Pre-App Comment Responses

July 25, 2017
Re: Dick's Sporting Goods #1343
The Southlands
Aurora, Colorado

The following are responses to the Pre-Application Meeting Comments dated July 7, 2017.

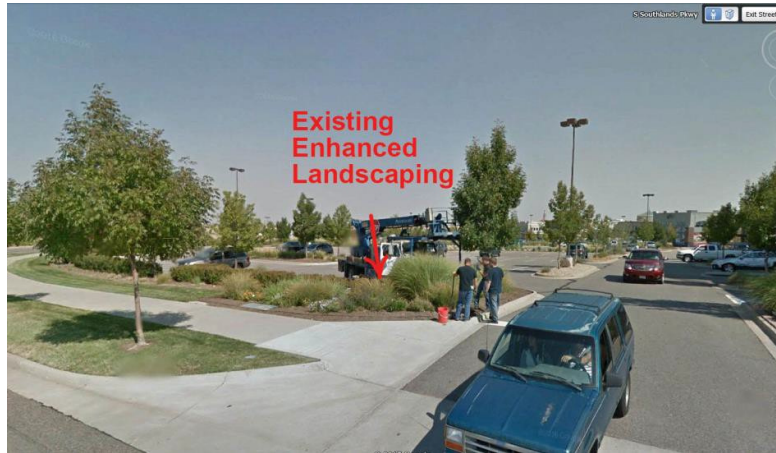
- **Parking Lot Landscaping and Screening.** *A number of trees will be removed/impacted by the proposed redesign of the entrance and parking area to the west or rear of the building. The interior of all parking lots shall be landscaped and the ends of all parking rows shall be terminated by a landscaped island. Not unlike the existing conditions now. Islands that are 9' by 36' or double islands shall be landscaped with two trees and 12 shrubs and/or ornamental grasses.*

If the existing perimeter parking lot landscaping along S. Southlands Parkway is impacted, the applicant shall be responsible for replacing the plant material so that the screening of the parking area is maintained. All visible parking lot perimeters shall be screened with one or a combination of methods shown in [Section 146-1440](#). If using plant material, screening shall consist of a continuous row of shrubs planted in a double row at 3 feet on center. Shrubs must reach a minimum of height of 3 feet at maturity and 50% must be deciduous flowering shrubs. Refer to [Section 146-1509](#) Parking Area Design. A continuation of the existing plant material would be preferred to maintain consistency of the landscape aesthetic. This also includes the replacement of the enhanced landscaping that is required at all site entrances. See the existing landscape image below.

- **Response:** Please see landscape plan for new planting – parking lot screen continued as currently planted. Corner enhanced landscape replanted based on the existing plants but rearranged to keep below sight triangles.
